BRIEF DESCRIPTION OF REQUEST
 Final sign-off on EPC amended site plan for La Mirada Shopping Center/Wymont Place subdivision.

**RE: The Wymont
4315 Wyoming Blvd NE
Conceptual Grading and Drainage Plans
Engineer's Stamp Date: No Date
Hydrology File: G19D004**

Project #2019-002309
SI-2021-00370—Site Improvement, Major Amendment to
Site Plan

Re: La Mirada/Wymont Place (PR-2019-002309, SI-2021-00370) Final Site Plan Sign-off

City of Albuquerque
 Planning Department
 Development Review Services
HYDROLOGY SECTION
PRELIMINARY APPROVED
 DATE: 08/04/21
 BY: *Ronald R. Bohannan*
 HydroTrans # G19D004

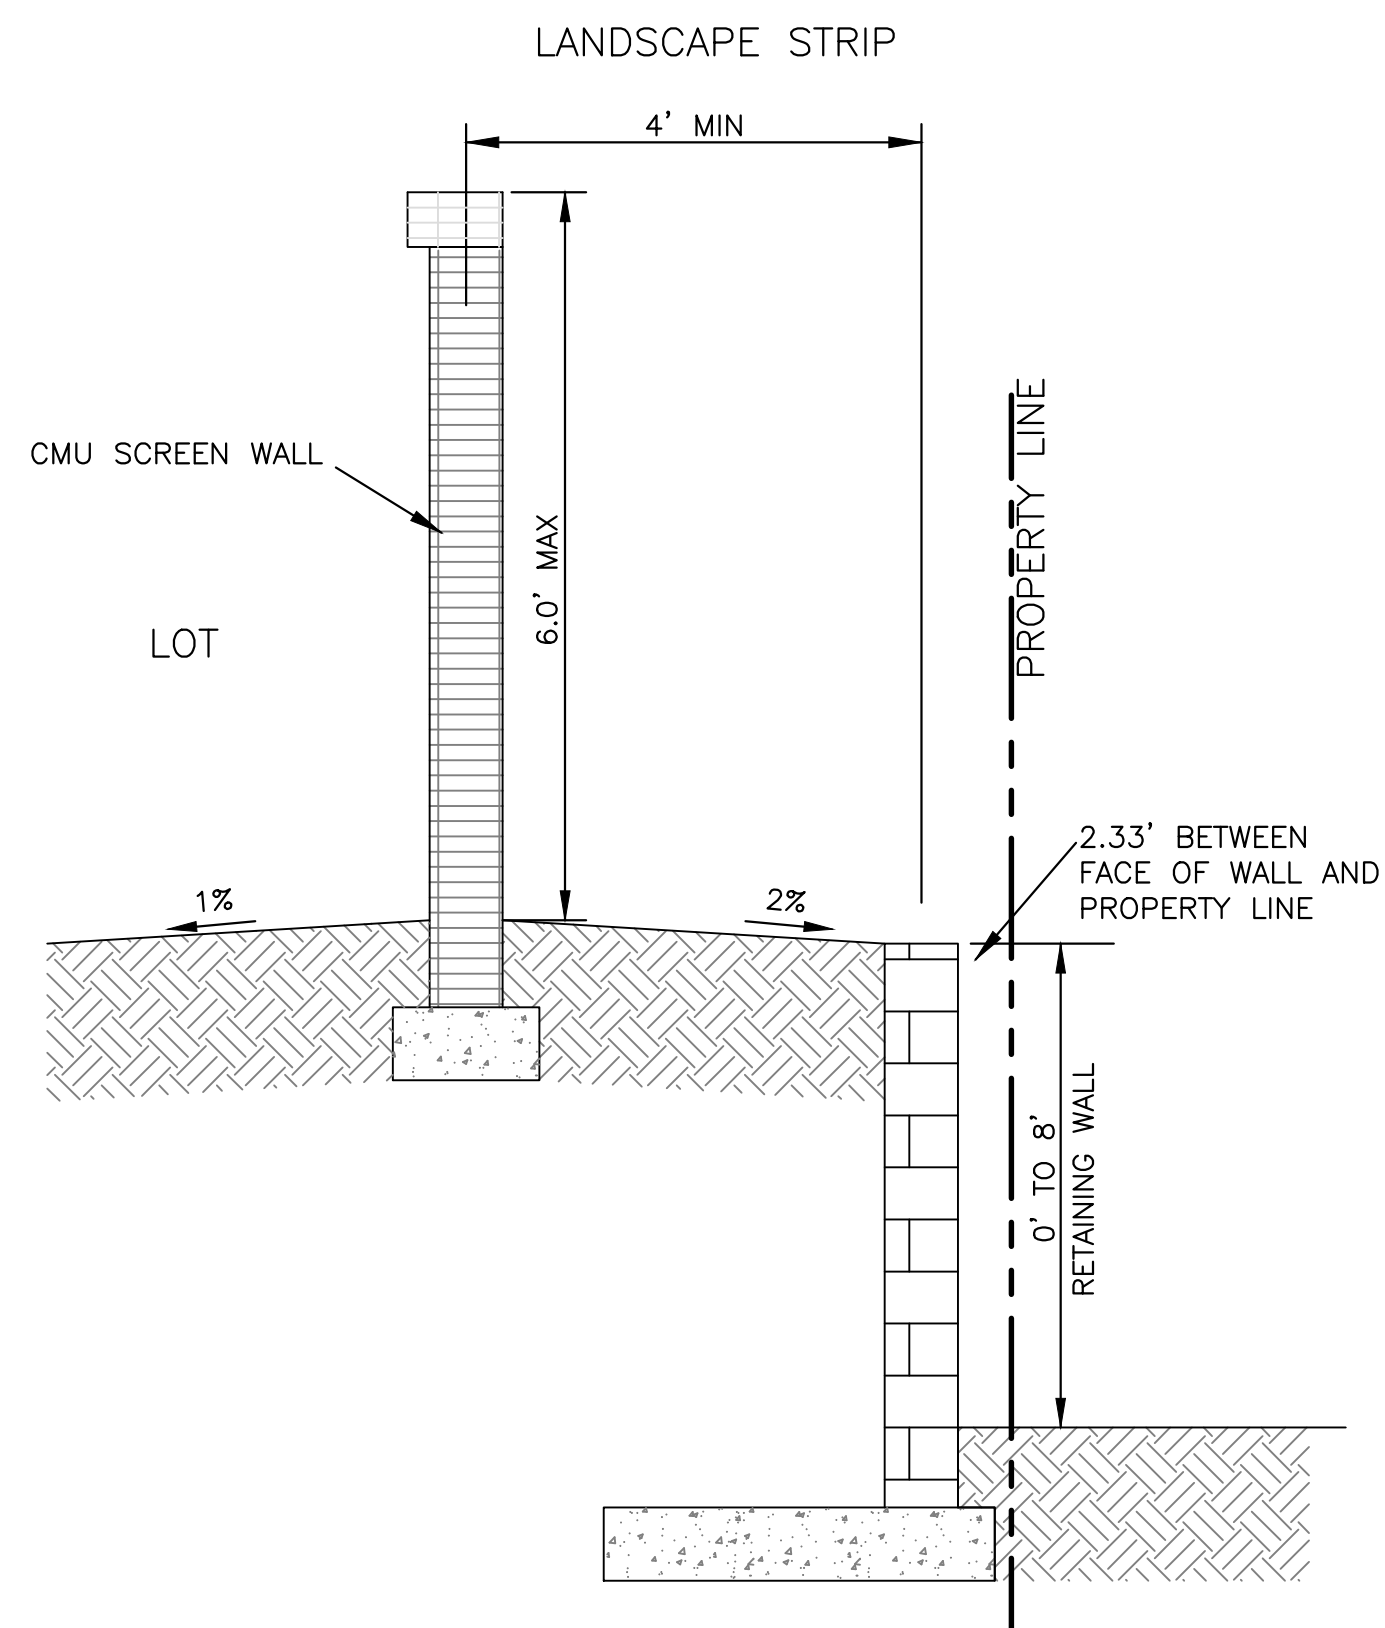
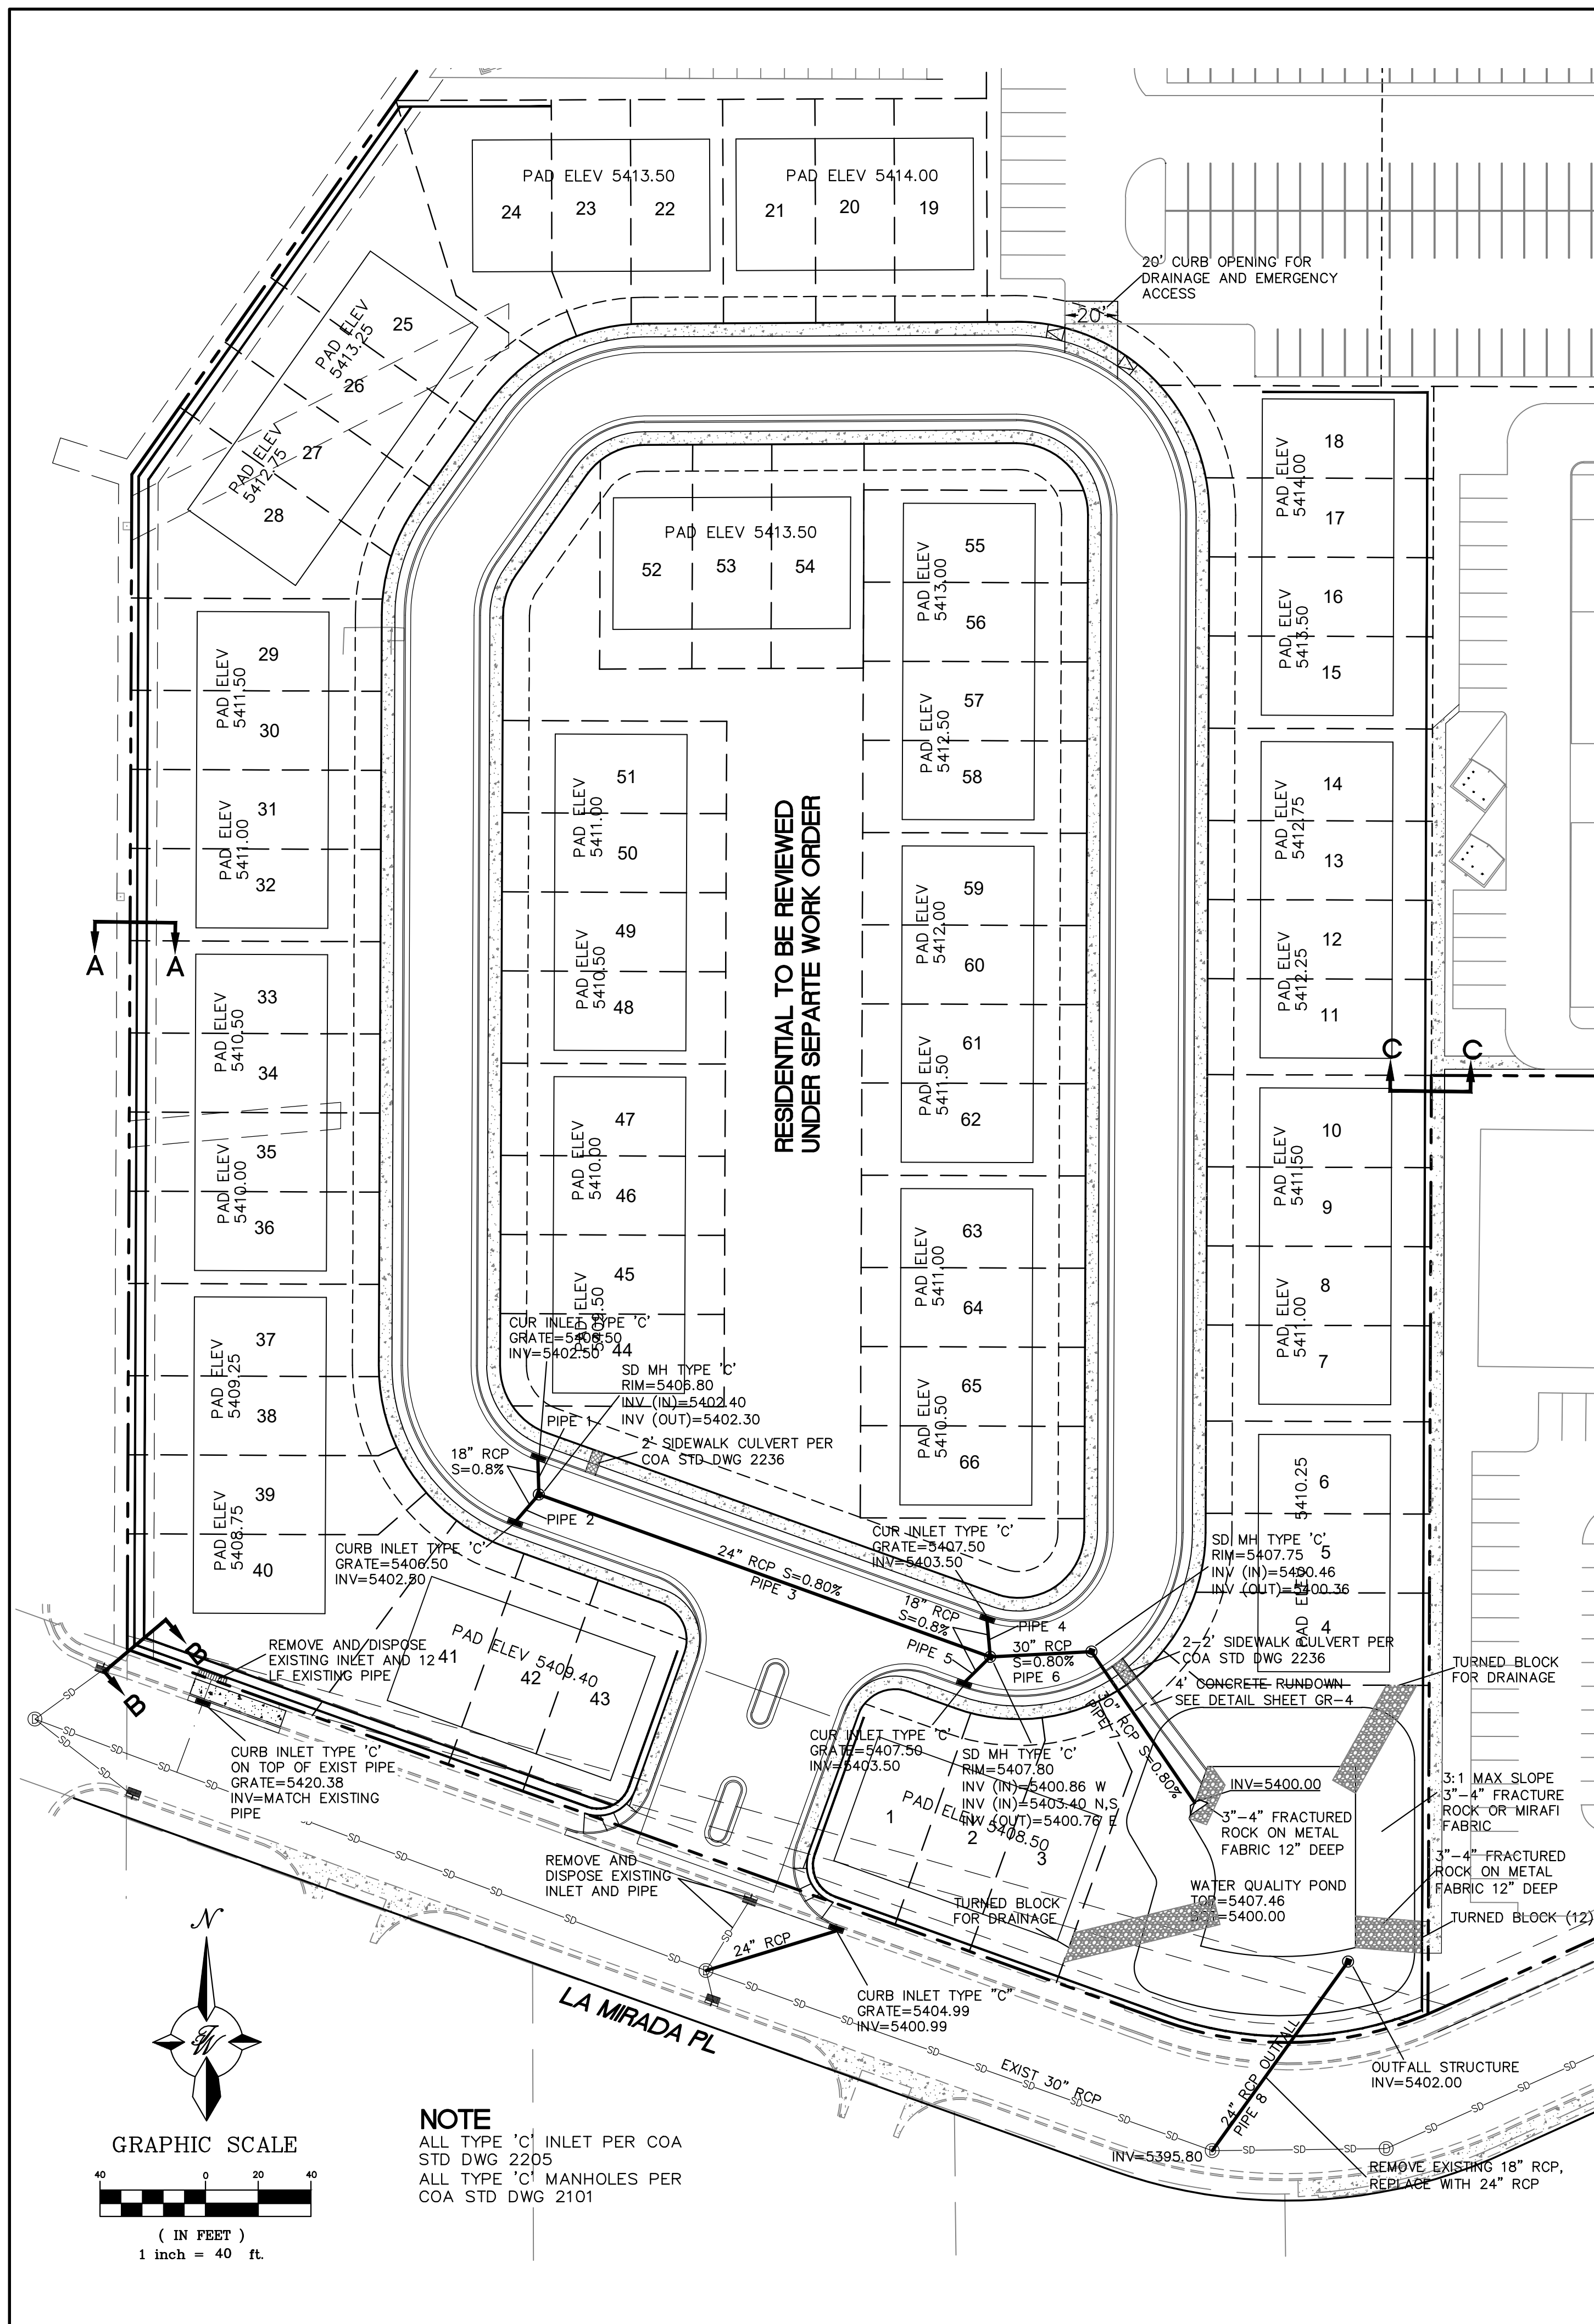
7. Walls:
Pursuant to IDO table 5-7-1 Maximum Wall Height, maximum wall height in Mixed Use zone districts is 8 feet. Currently, wall sections show terraced walls with a range of up to 12 feet in height. Any wall that is proposed to be higher than 8 feet will need additional approval from the City Engineer, pursuant to IDO Subsection 14-16-5-7(F)(1)(a).

The terraced walls have been updated to comply with this requirement as shown on Sheet GR-2.
